Access Compliance Report Public Rights-of-Way (Curb Ramps)

Main Street: NEWPORT_AVE Cross Street: DODGE_AVE Location: SE

ADA ID: RPRK220126111951 Ramp Type: Type 4 - Parallel Initial Pass/Fail: Fail Overall Compliance: No Severity Score: 2

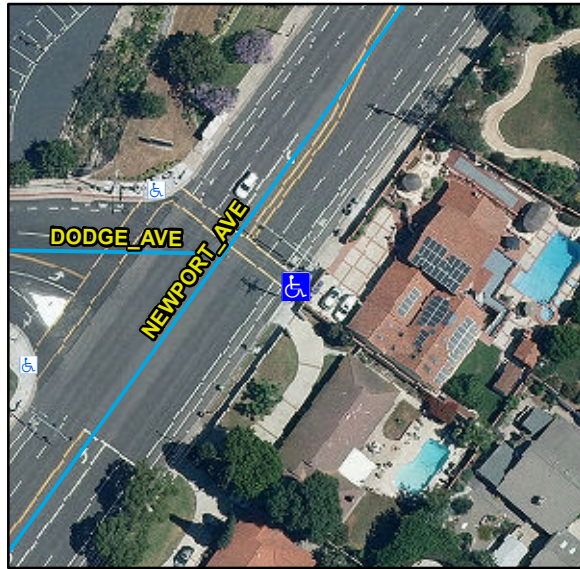
R304.5.3, R302.3, R402.2, STD 1115

Compliance	Description	Data	Compliance	Description	Data
N/A	Ramp Length LT (in)	121	N/A	Ramp Length RT (in)	70
Yes	Ramp Width LT (in)	84	Yes	Ramp Width RT (in)	84
Yes	Ramp Run Slope LT (%)	5.2	Yes	Ramp Run Slope RT (%)	6.1
Yes	Ramp Cross Slope LT (%)	1.1	No	Ramp Cross Slope RT (%)	3.1
N/A	Landing Present	N/A	N/A	DWS Provided	N/A
N/A	Landing Length (in)	N/A	N/A	DWS Contrast	N/A
N/A	Landing Width (in)	N/A	N/A	DWS Length (in)	N/A
N/A	Landing Run Slope (%)	N/A	N/A	DWS Full Width	N/A
N/A	Landing Cross Slope (%)	N/A		DWS Offset Type	N/A
N/A	Landing Movement Obstructed?	N/A	N/A	DWS Offset Left (in)	N/A
	Landing Movement Type	N/A	N/A	DWS Offset Right (in)	N/A
N/A	Landing Shared	N/A			
N/A	Clear Space	N/A			
N/A	Clear Space To Crosswalk (in)	N/A			
N/A	Marked Crosswalk 1	Yes	N/A	Marked Crosswalk 2	N/A
	Crossing 1 Direction	NW		Crossing 2 Direction	N/A
	Marked Crosswalk 1 Width (in)	144		Marked Crosswalk 2 Width (in)	N/A

Remove & Replace Entire Ramp. Restripe Crosswalk.
